MINUTES OF THE HOWEY IN THE HILLS PLANNING AND ZONING BOARD
HELD DECEMBER 14, 2017

Consideration and Recommendation to the Town Council regarding proposed amendments to Section 5.01.03 of the Land Development Code. (Sheds).

PLEASE SEE ATTACHED DIAGRAM

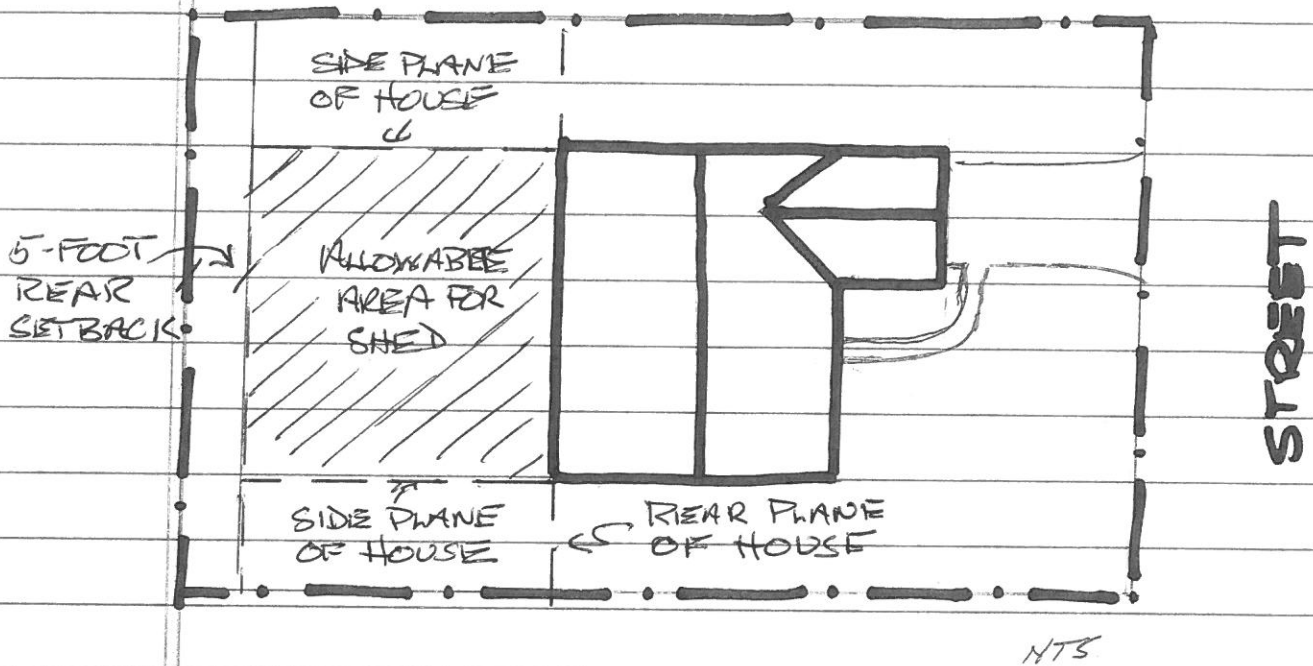
Member Wells asked if storage sheds came in neutral colors. **Town Planner Harowski** replied typically.

Member Ricci said that he would like to see storage sheds restricted to the same plane as regular sheds. **Town Planner Harowski** said that he would add that verbage.

Member Wells asked if the shed exceeds one hundred and forty four square feet (144sqft) does the setbacks change. **Town Planner Harowski** replied no.

Member Ricci asked Member Wells if he was recommending setting a different set back if the shed exceeds one hundred and forty four square feet (144sqft). **Member Wells** replied yes, may be an eye soar to surrounding neighbors due to the size.

Member Wells and Member Ricci asked that the verbage be added that over one hundred and forty four square feet (144sqft) the shed must comply with the accessory structure section of the Land Development Code.

Member Wells asked if a shed could be placed on a rear easement. **Town Planner Harowski** replied no but maybe an exception for a rare case.

Member Ricci, seconded by Member St. Clair moved to recommend to the Town Council the proposed amendments to Section 5.01.03 of the Land Development Code with the verbage added that the storage sheds be placed in the same plane as sheds and sheds over 144 square feet shall comply with the setback requirements for accessory structures as set forth in Section 5.01.03F Motion passed unanimously.
